**Technical Service
BULLETIN**

INSTALLATION INSTRUCTION CHANGE

'04 Highlander

ACCESSORIES
AX002-04

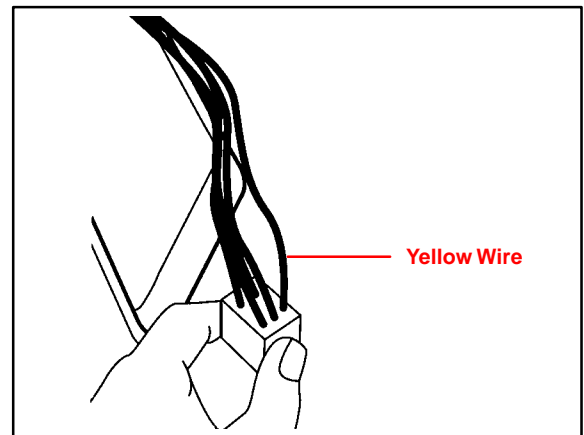
Introduction The Toyota accessory, Auto Dimming Mirror (PT374-48020), installation instructions describes a T-tap connector to the red-blue wire, pin #3 in connector IB2. The factory made a running change to the color of the wire from red-blue to yellow. The connector and pin number location are unchanged.

1. Change paragraph E8ii from "Locate the red-blue, pin #3, in connector IB2" to read "Locate the YELLOW wire, pin #3, in connector IB2."
2. Change paragraph E9 from "Apply the red T-tap connector to the Red-Blue wire to read "Apply the red T-tap connector to the YELLOW wire."
